CITY OF ALBUQUERQUE

**RE: Chase Bank - Eubank
340 Eubank NE
Grading and Drainage Plan Stamp Date: 9/16/20
Hydrology File: K21D009C**

Based on the submittal received on 9/3/20, the Grading and Drainage Plan cannot be approved until the following are corrected:

C5.01

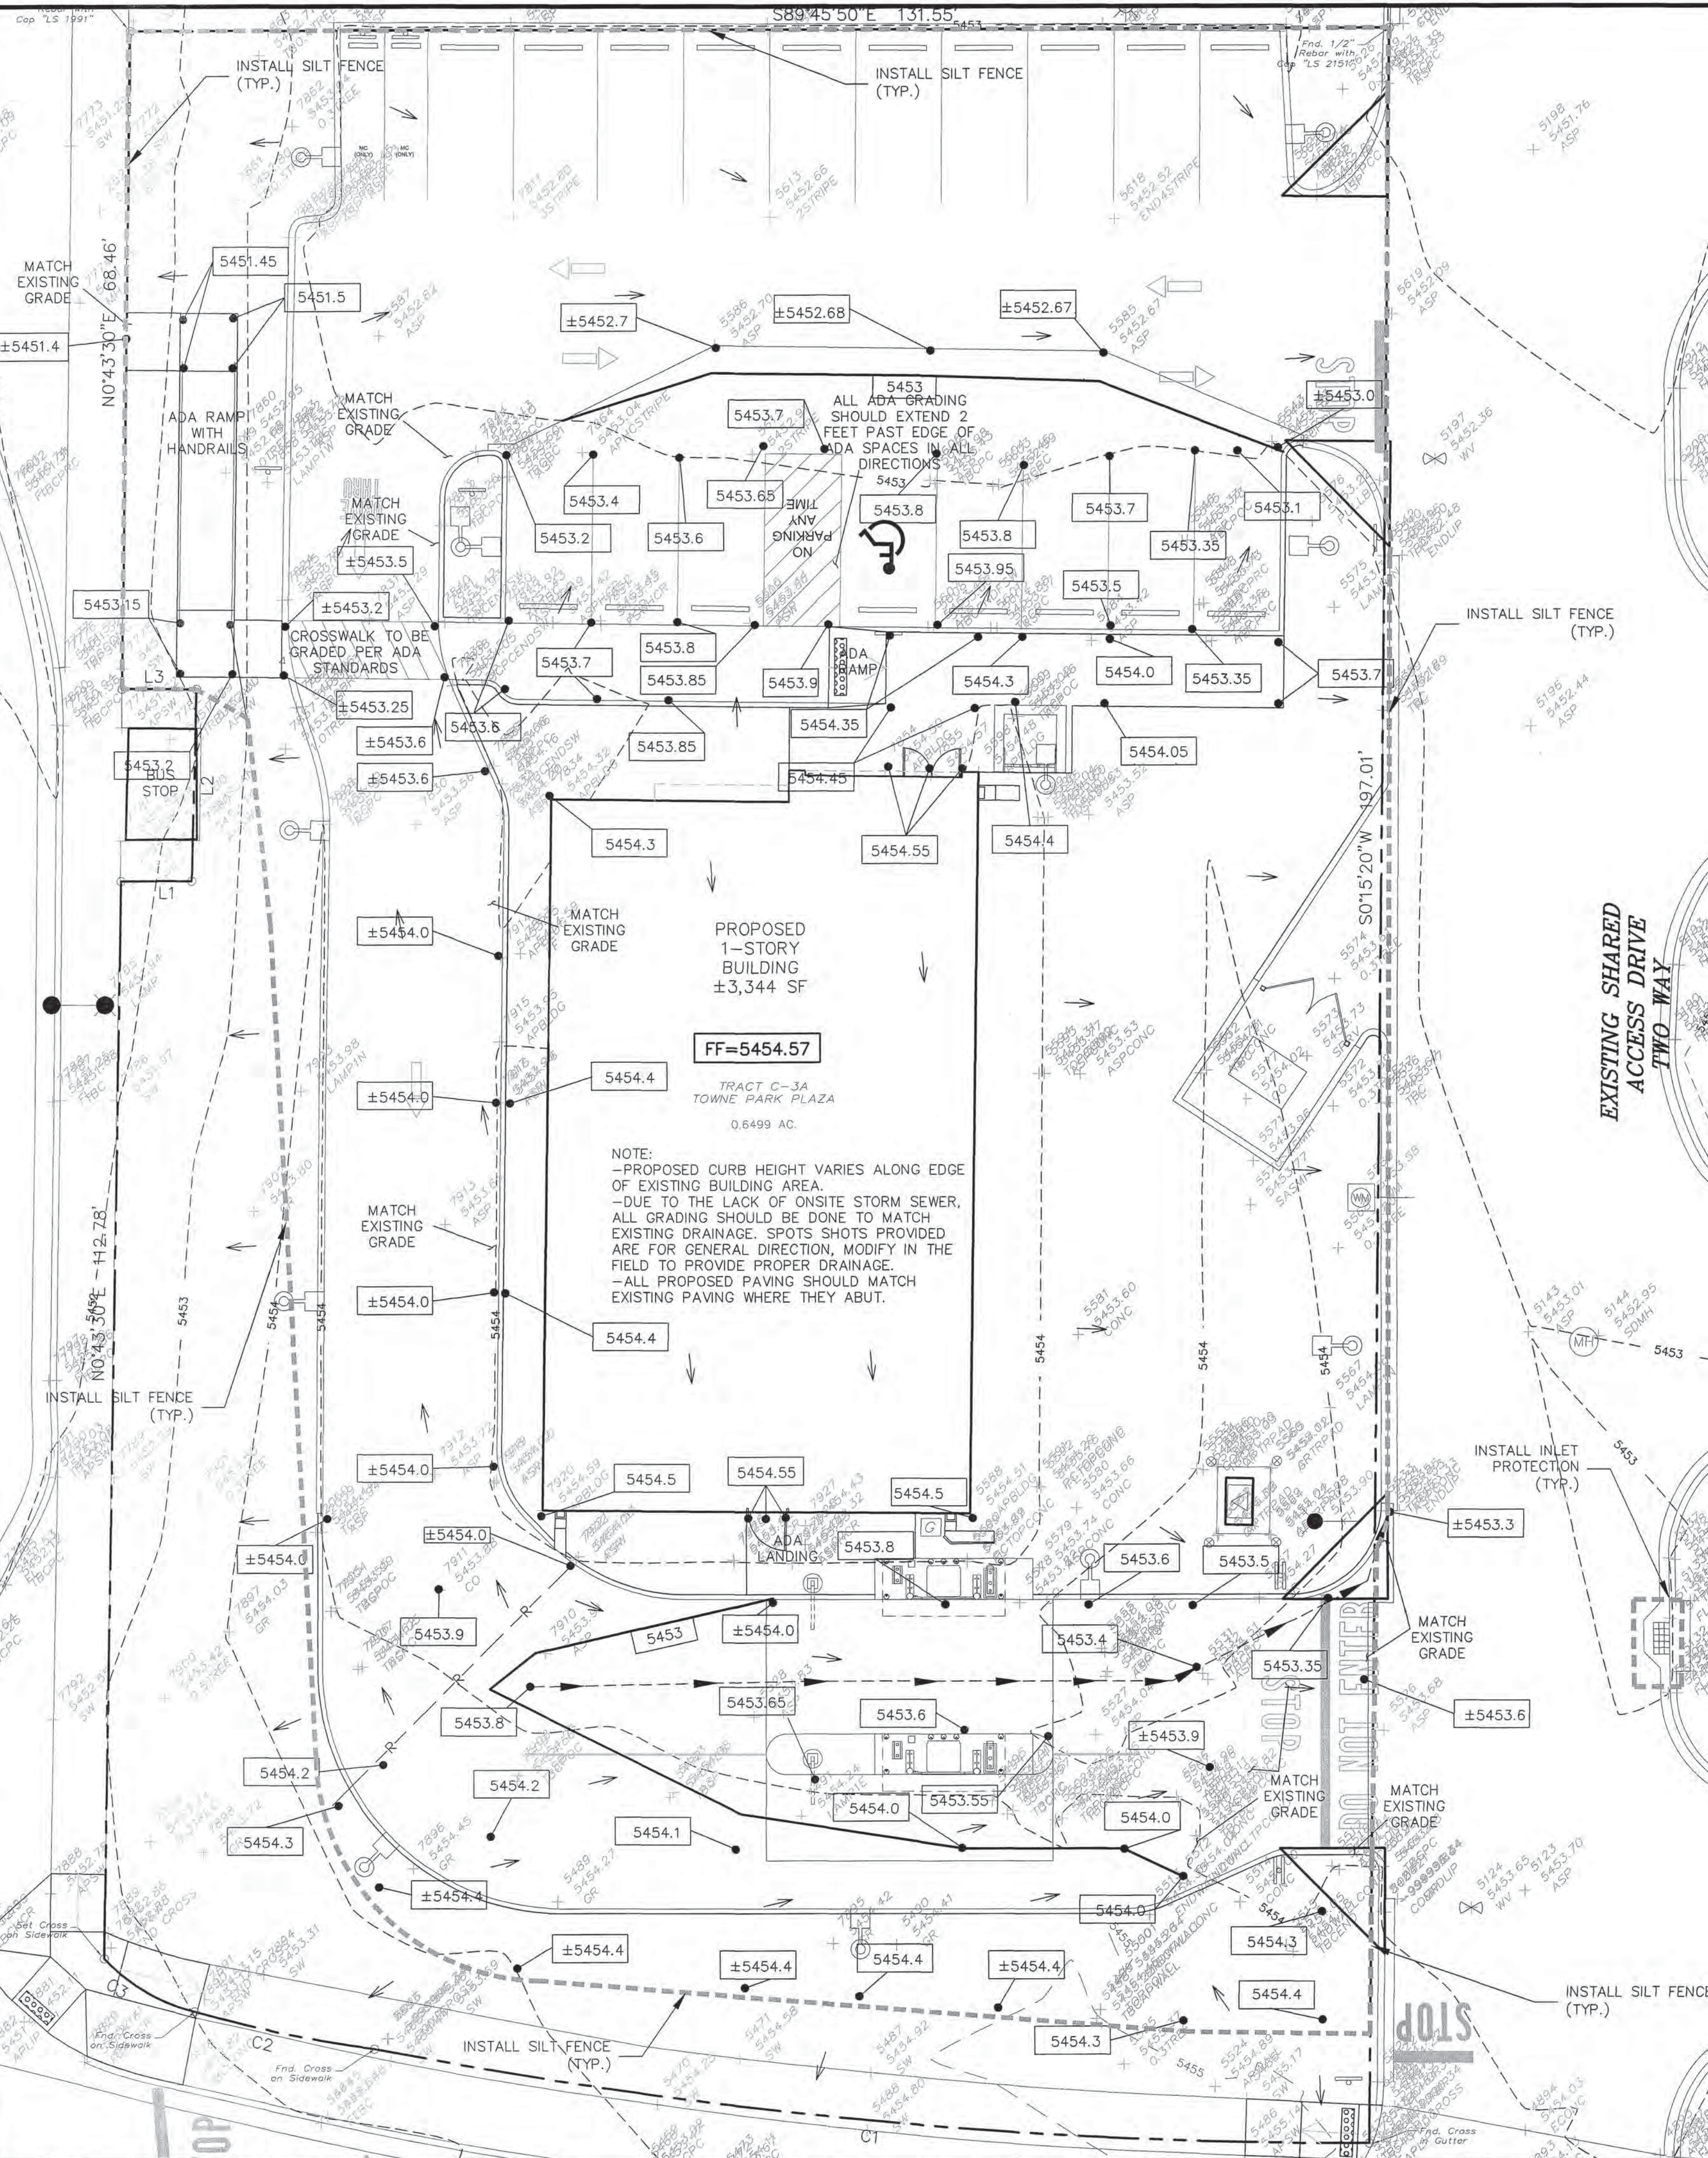
1. Please provide drainage calculations for the existing and proposed conditions per the City's Development Process Manual (DPM) Chapter 6 available on the City's website.

2. Please provide a vicinity map showing the location of the site. Typically this is the Zone Atlas. This can be downloaded in pdf format from the City of Albuquerque's website.

3. Provide management onsite for the Stormwater Quality Volume (SWQV) in accordance with the new drainage ordinance, § 14-5-2-6 (H) enacted 10/2/18 (Council Bill C/S O-18-2). To calculate the required volume to be captured, multiply the impervious area (SF) by 0.34 inches for the 90th percentile storm.

4. Please number the ponds and include a label on each with the SWQV and elevation, the 100-year volume and elevation, the peak 100 year inflow and outflow, the spillway crest elevation, the spillway flow depth, and the dam top elevation.

5. Please provide the SWQV calculations for each basin draining to each pond. The stormwater quality ponds need to be sized for the areas draining to them.
